**SAAB****SERVICE INFORMATION**

SI No. 410-1976

Clutch operation complaints

LHD cars with manual gearbox M94-97

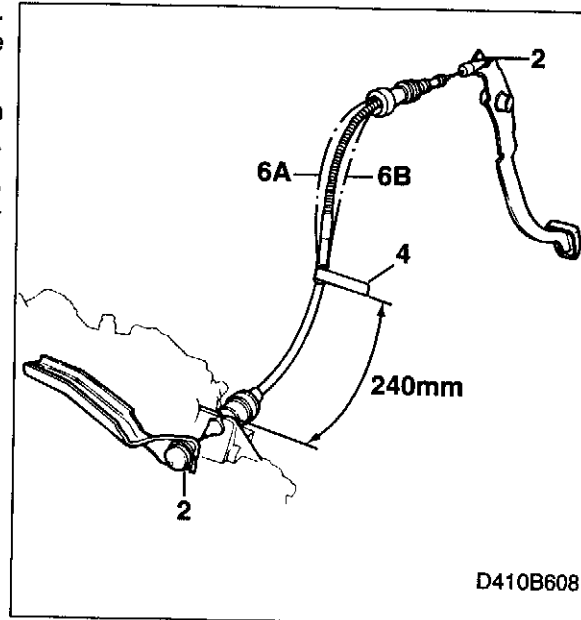
The adjusting mechanism must be completely pressed in towards the firewall for the adjustment to function. Also note that the locating bracket (figure 4) is critical to the correct adjustment and operation of the clutch and cable.

- 4 Inspect and replace bracket, P/N 44 90 249 and screw, P/N 79 72 805, if damaged. Check that the bracket is centered on the sleeve and that the sleeve is fitted according to the measurement in the illustration. Tighten the bracket to the body.
- 5 Check that there is free play in the clutch pedal.
- 6 Check that the clutch cable follows the upper curve (6A) if the clutch is new. There is a need for some excess, since the cable casing is stretched when the clutch is worn and the adjusting mechanism will compensate for this. When the clutch is worn, the cable will follow the lower curve (6B).
- 7 Make sure that the clutch cable has a smooth routing without any kinks or sharp bends.
